MONTEREY PENINSULA WATER MANAGEMENT DISTRICT

July 8, 2004

Subject: Monterra Ranch Mutual Water Company (MRMWC) Annual Water Monitoring Program Report for Water Year 2003

Monterra Ranch Mutual Water Company Water Year 2003 Potable and Sub-Potable Uses

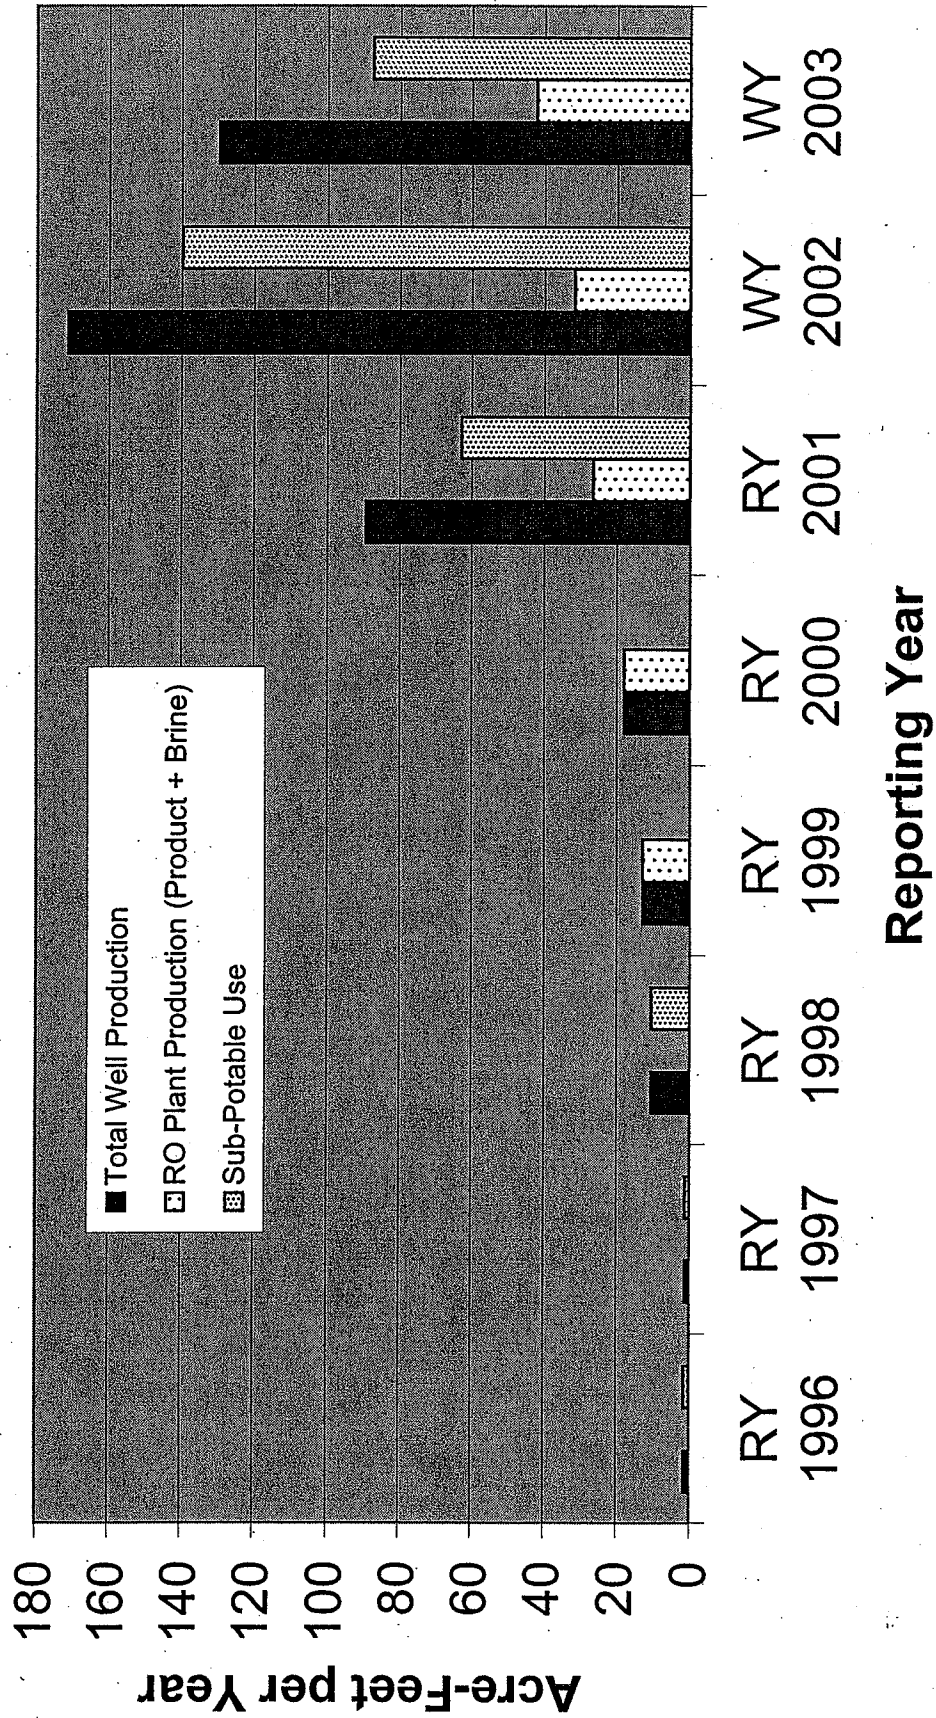
1. Breakdown of Monthly Well Production. Some confusion was expressed regarding interpretation of the monthly well production data presented in Table R-1 of the Questa May 14, 2004 letter. This confusion centered on representation of these data in units of equivalent *gallons per day* (gpd) of well production. We recognize the purpose for showing production in equivalent gpd units is for comparison with the well production capacity data, which were originally developed and reported in gpd units. However, as a means to make the production data easier to visualize and interpret, we have prepared a graphical plot (**Enclosure 1**) showing the breakdown of monthly production in terms of potable and sub-potable uses. This plot uses the data from Table R-2 of the Questa May 14, 2004 letter, which includes essentially the same monthly production data as Table R-1, except represented in units of total acre-feet per month. As shown on the plot, the sub-potable uses are broken down into two categories: (a) "Sub-Potable (Well M1)", and (b) "Other Sub-Potable". Note that we changed the label title for "Other Sub-Potable" from its title of "Non-metered Sub-Potable" in Table R-2 to avoid the potential misinterpretation that some production from the wells is not metered. It is our understanding that Well M1 is dedicated to construction watering and roadside irrigation use. "Other Sub-Potable" is therefore the remainder when "Potable"

and "Sub-Potable (Well M1)" are subtracted from production. Accordingly, this means that the "Other Sub-Potable" values would also include any losses that might be occurring in that part of the distribution system. As discussed on page 12 of the WY 2003 report and in response to Comment 13 in the Questa May 14, 2004 letter, it is our understanding that the "Other Sub-Potable" use category should become smaller in the future as the reporting of additional uses such as golf course irrigation becomes available, due to recent flow meter installations. We recommend that a plot similar to **Enclosure 1** be included in future annual reports as a means to more easily assimilate the monthly use data. Please comment.

Monterra Ranch Mutual Water Company Summary of Annual Well Production, RO Plant Production and Sub-Potable Use

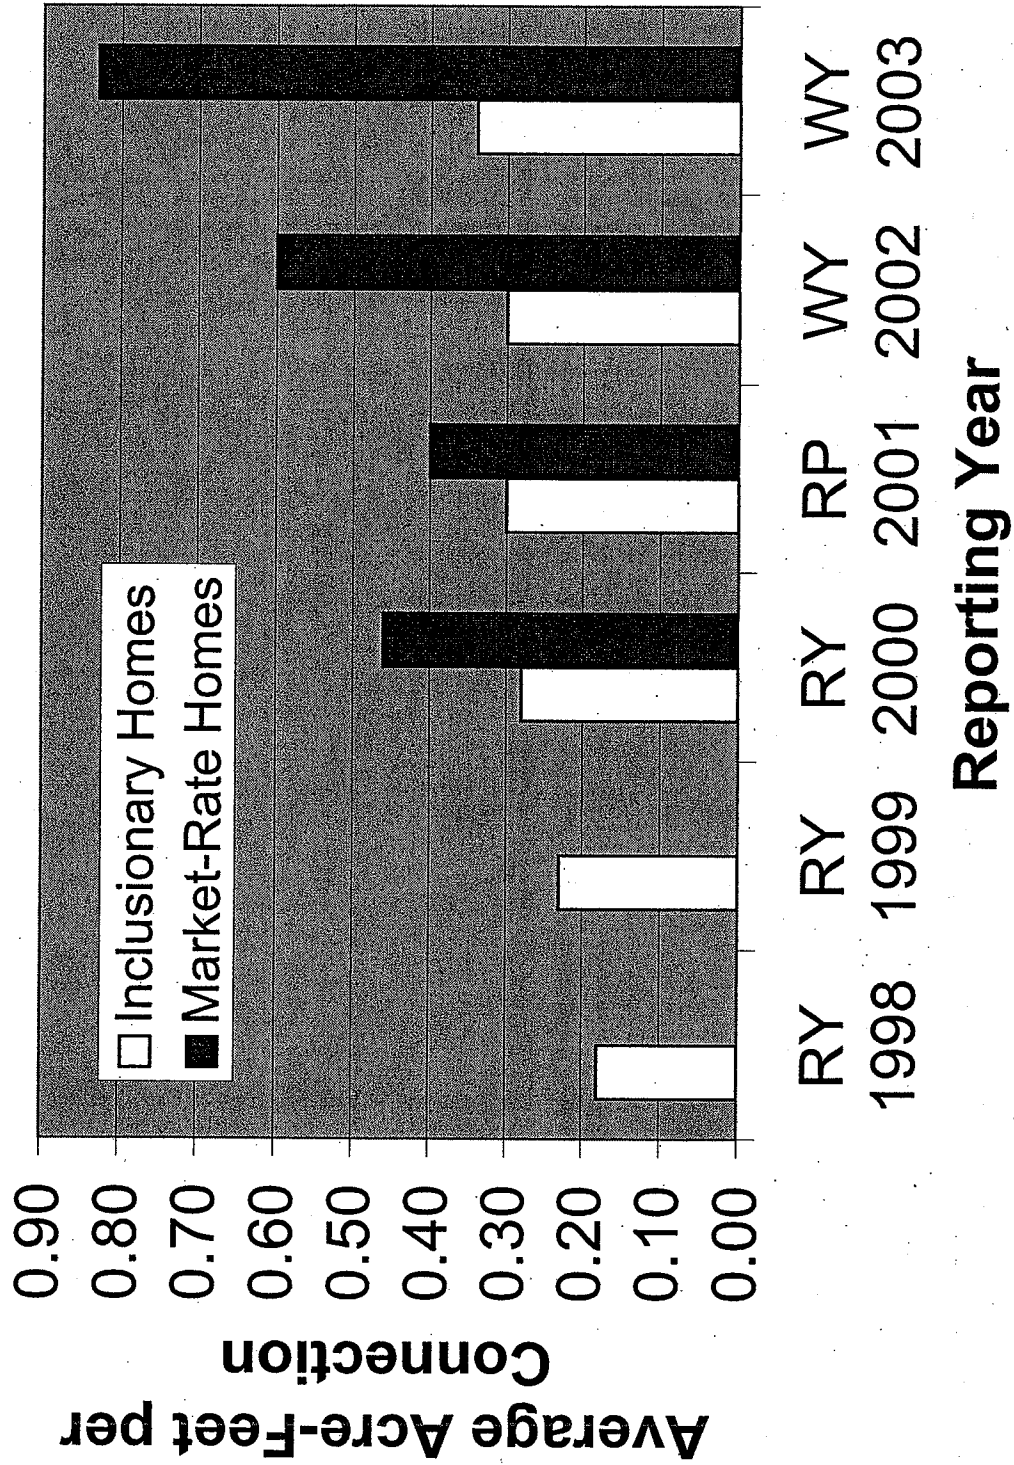
2. Summary of Annual Well Production, Reverse Osmosis (RO) Plant Production and Sub-Potable Use. Similar to the comment above, the plot shown as **Enclosure 2** was prepared to show pertinent annual production and use data in a format that enables easier visualization of trends over time. The "Total Well Production" and "RO Plant Production" values are from Table 1 of the WY 2003 report. The "Sub-Potable Use" values are the remainder when "RO Plant Production" is subtracted from "Total Well Production", and accordingly would include any losses that might be occurring in the sub-potable part of the distribution system. This plot allows, at a glance, how changes have occurred in water that is produced and used within the MRMWC system over time. We recommend that a plot similar to **Enclosure 2** be included in future annual reports as a means to more easily assimilate the annual production and use data. Please comment.

Monterra Ranch Mutual Water Company Summary of Annual Residential Use

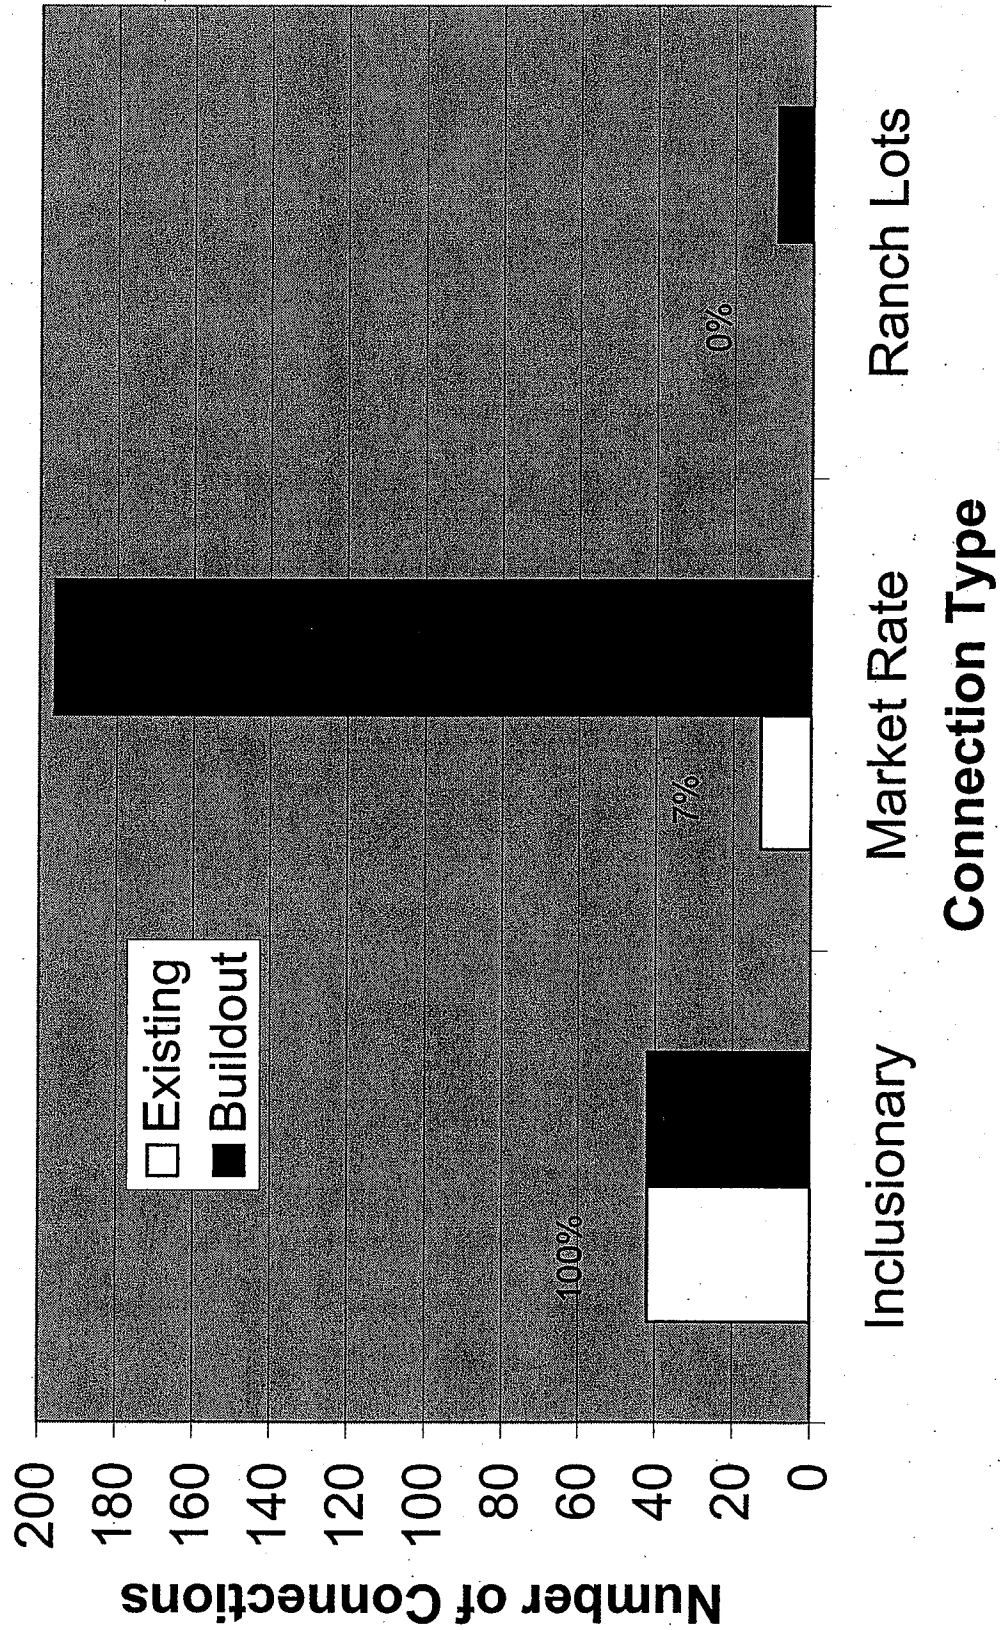
3. Summary of Annual Residential Water Use. The plot shown as **Enclosure 3** was prepared to summarize annual water use for the two existing residential unit types (i.e., Inclusionary and Market-Rate Homes). The data used to compile this plot is from Table 1 of the WY 2003 report. This plot facilitates assessment of changes in annual water use rates over time. We recommend that a plot similar to **Enclosure 3** be included in future annual reports as a means to more easily assimilate the annual water use data. Please comment.
